SOLACE AT CIMARRON HILLS  
- FILING NO. 1  
SITE AND OVERALL UTILITY PLAN  
SHEET 4 OF 32  
JOB NO. 25174.00

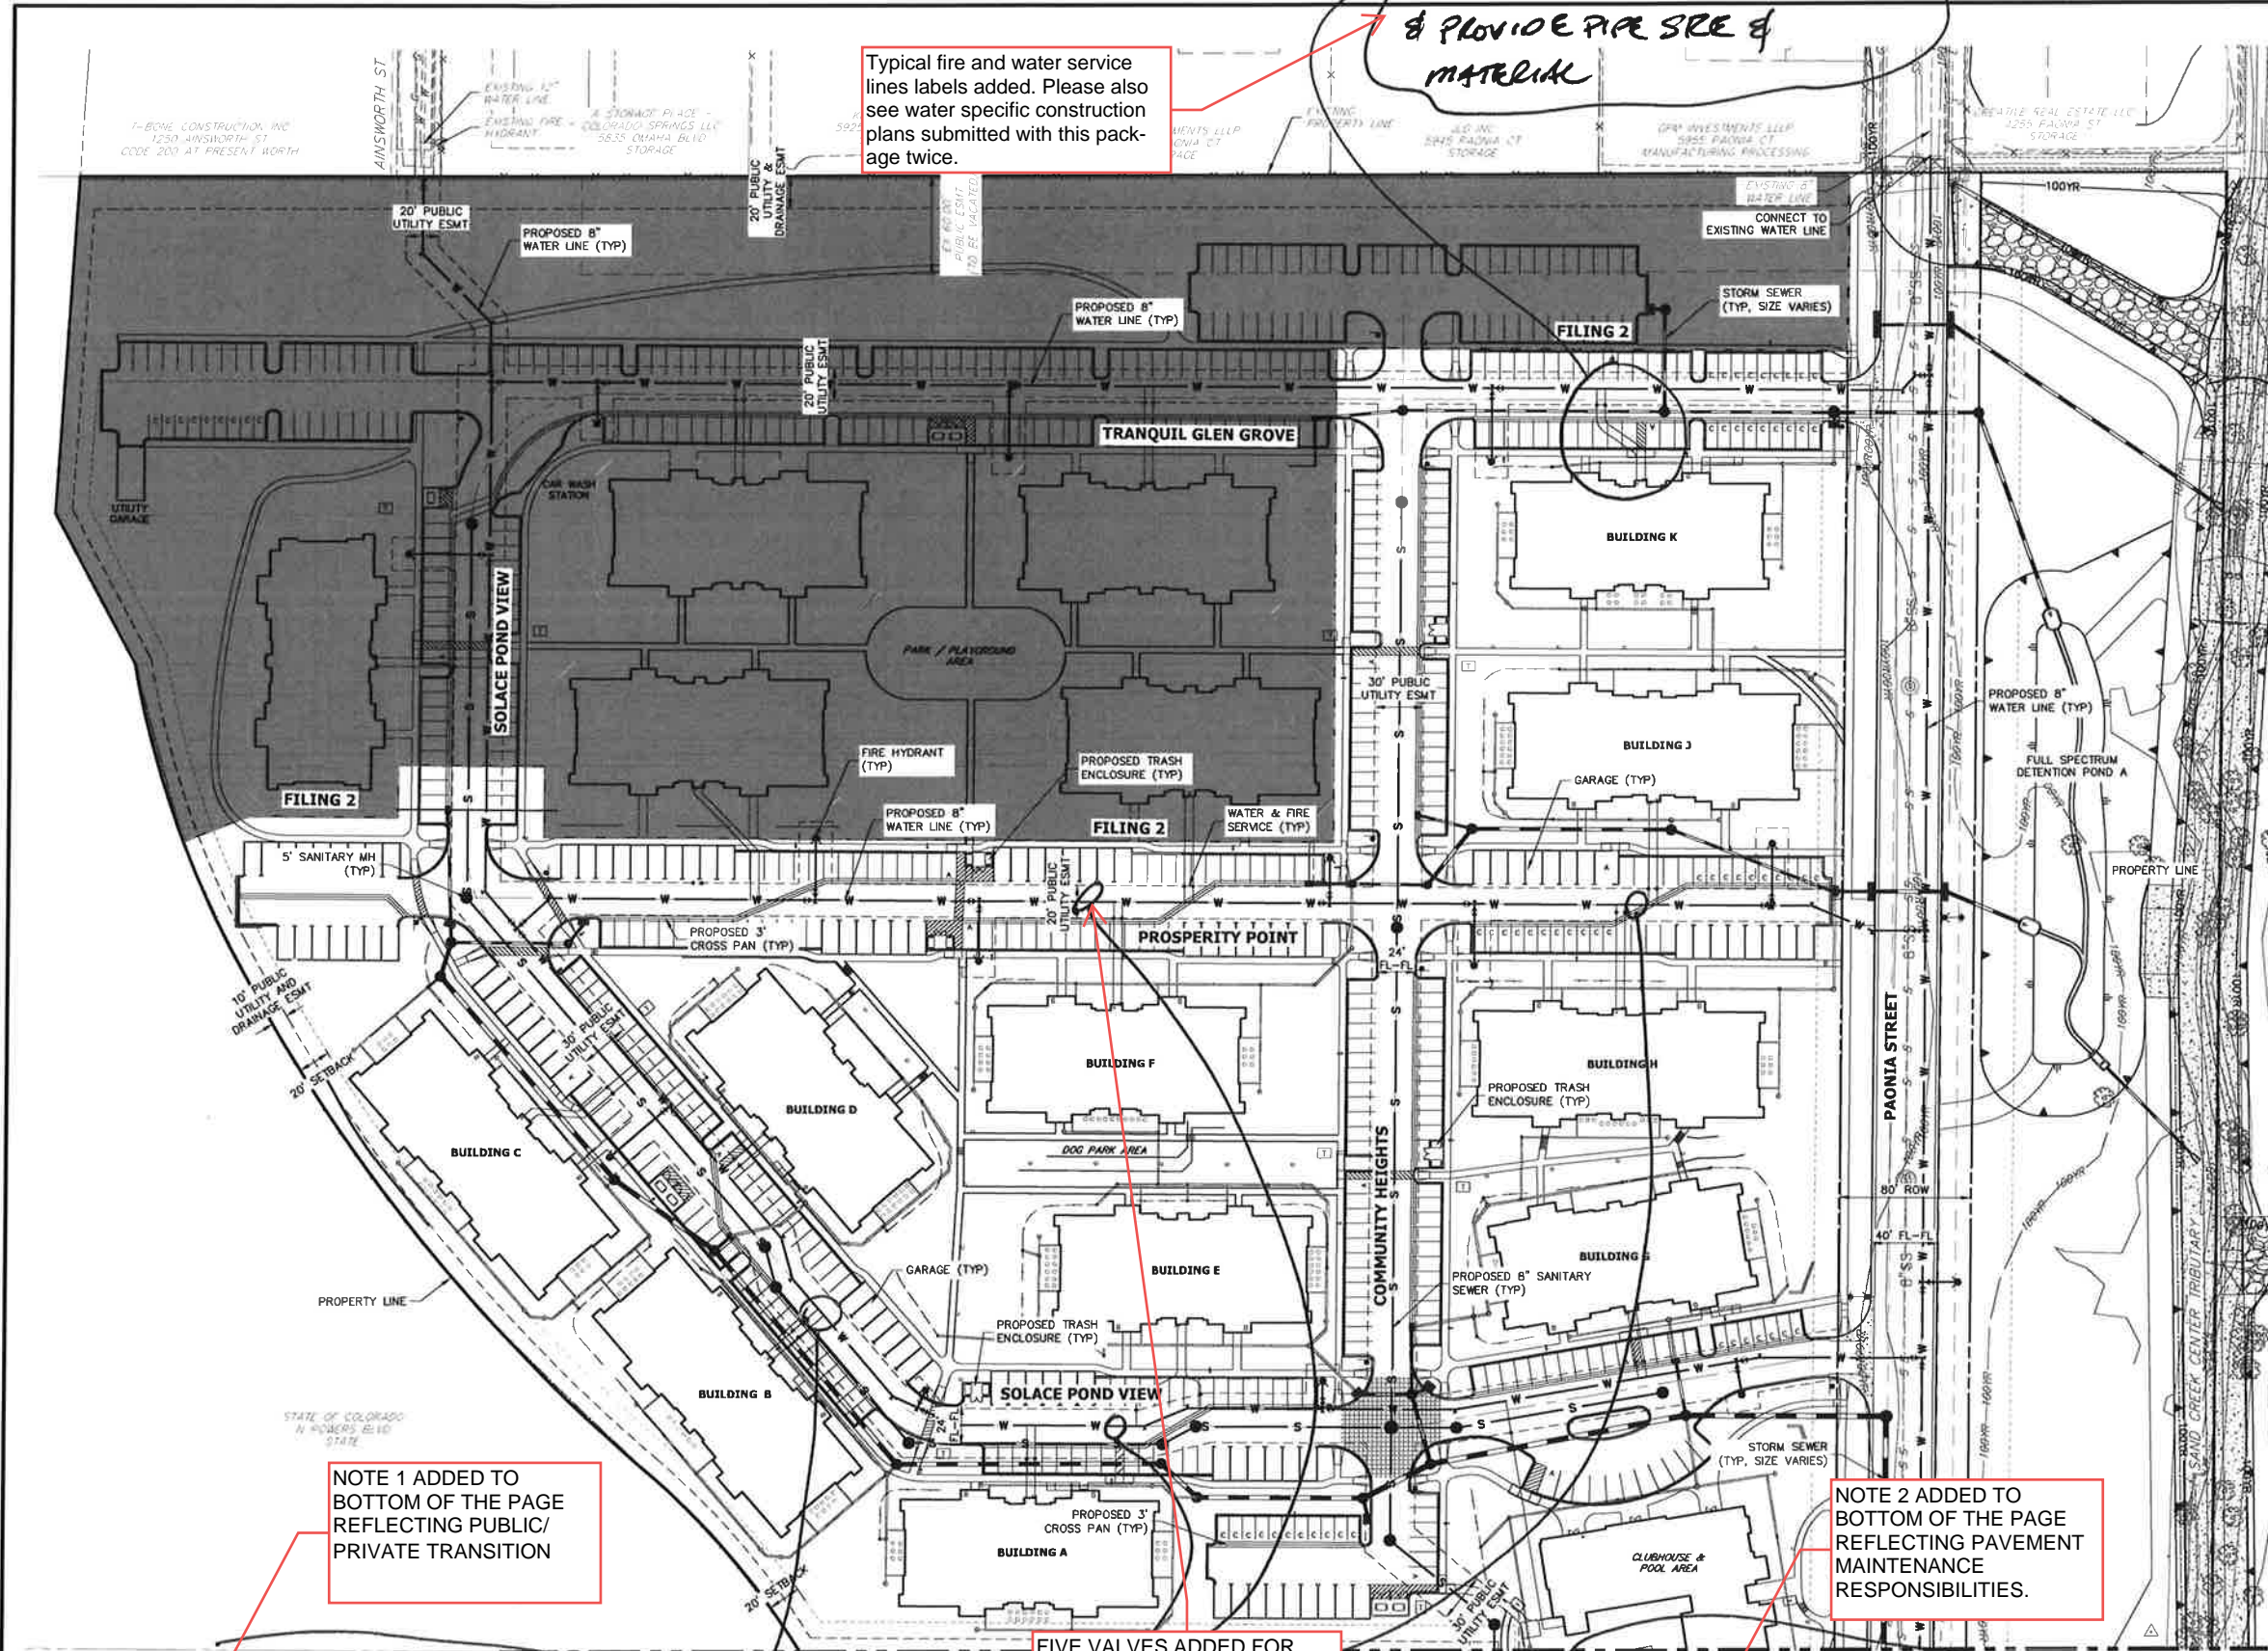
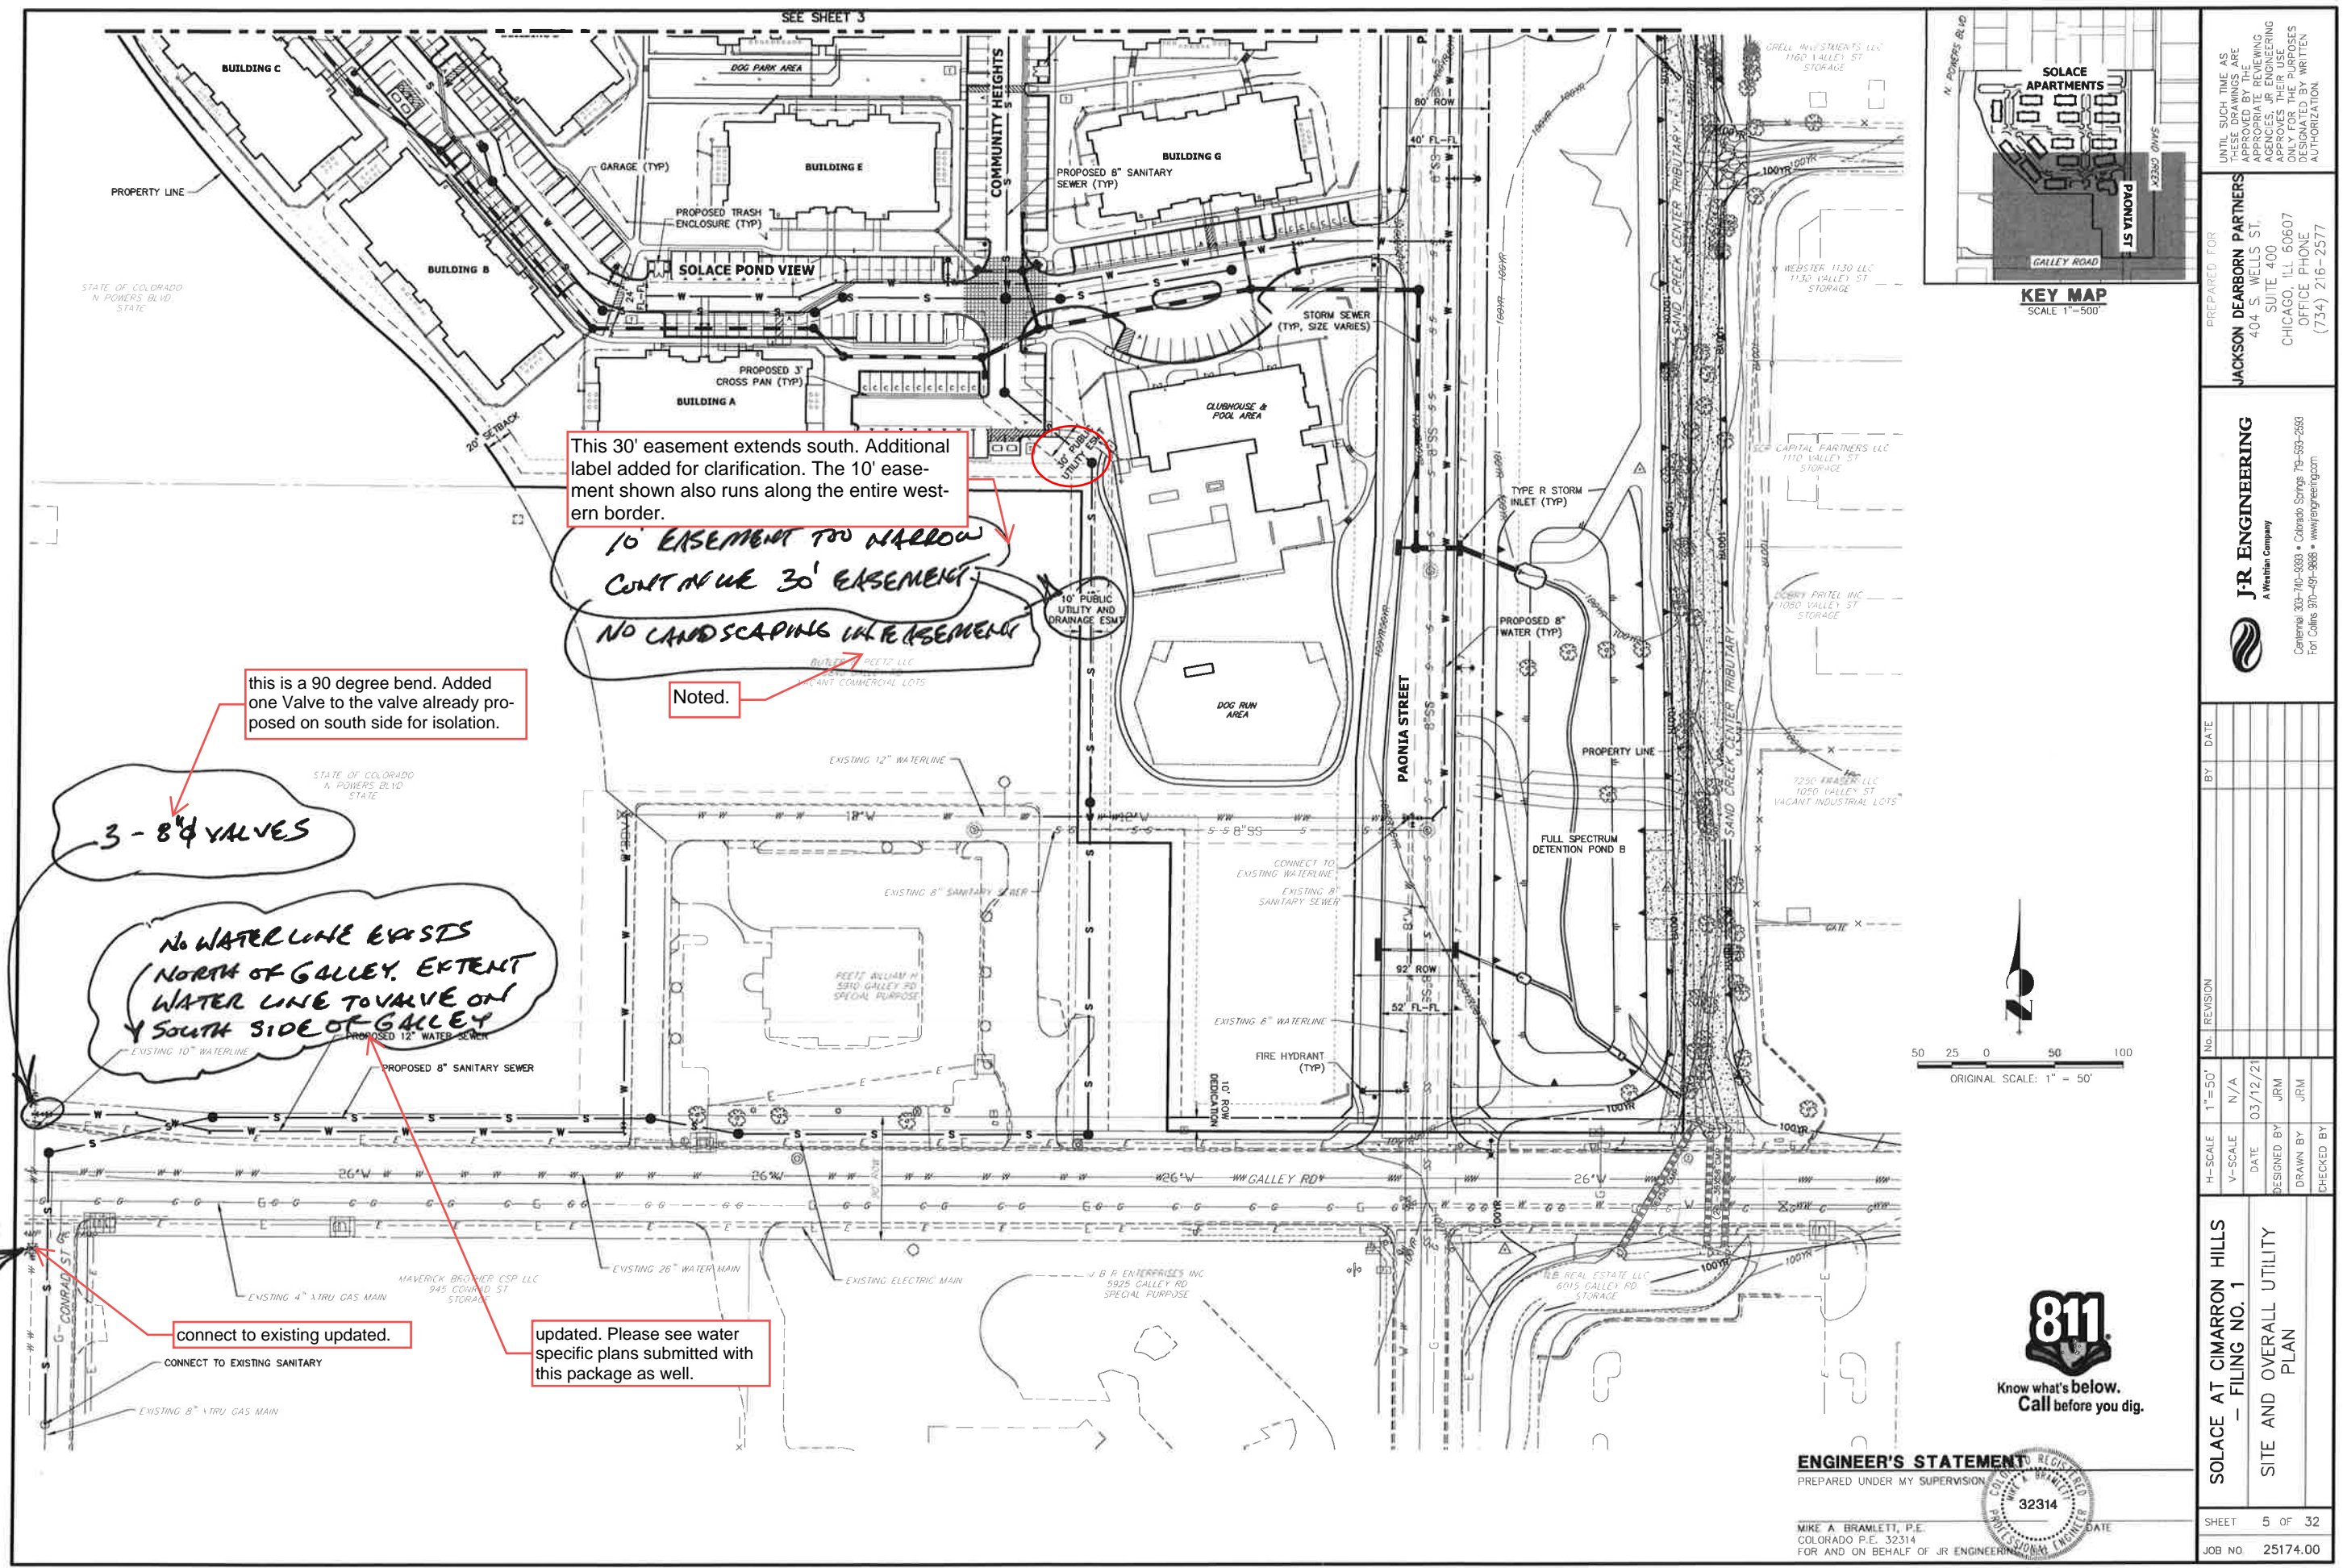
3 Label Service & FIRE LINES & PROVIDE PIPE SIZE & MATERIAL

1 SHOW SANITARY SEWER CONNECTION TO BLDG.

2 IF PUBLIC SANITARY WATER & SEWER SYSTEMS SUBMIT PIPE PROFILES W/ CROSSING DETAILS

4 IF PUBLIC WATER SYSTEM ADD NOTE THAT CHEROKEE RESPONSIBILITY ENDS AT MAIN TRAP VALVE - SERVICE TO BLDG IS OWNER'S RESPONSIBILITY

5 ADD VALVES TO ISOLATE BUILDINGS

6 IF PUBLIC WATER & SANITARY SYSTEMS- ADD NOTE THAT OWNER RESPONSIBLE FOR PAVEMENT REPLACEMENT IF REPAIRS ARE NEEDED

Typical fire and water service lines labels added. Please also see water specific construction plans submitted with this package twice.

Noted. Please also see sanitary specific construction plans submitted with this package twice.

Public. Please also see sanitary specific construction plans submitted with this package. These include all profiles and crossing details.

NOTE 1 ADDED TO BOTTOM OF THE PAGE REFLECTING PUBLIC/ PRIVATE TRANSITION

NOTE 2 ADDED TO BOTTOM OF THE PAGE REFLECTING PAVEMENT MAINTENANCE RESPONSIBILITIES.

FIVE VALVES ADDED FOR INDIVIDUAL BUILDING SERVICE ISOLATION.

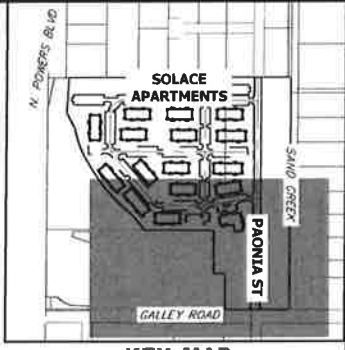
10' EASEMENT TOO NARROW CONTINUE THE 30' EASEMENT NO LANDSCAPING IN EASEMENT

3 - 8" VALVES

No WATER LINE EXISTS NORTH OF GALLEY. EXTEND WATER LINE TO VALVE ON SOUTH SIDE OF GALLEY

CONNECT TO EXIST VALVE

This 30' easement extends south. Additional label added for clarification. The 10' easement shown also runs along the entire western border.

Noted.

this is a 90 degree bend. Added one Valve to the valve already proposed on south side for isolation.

connect to existing updated.

updated. Please see water specific plans submitted with this package as well.
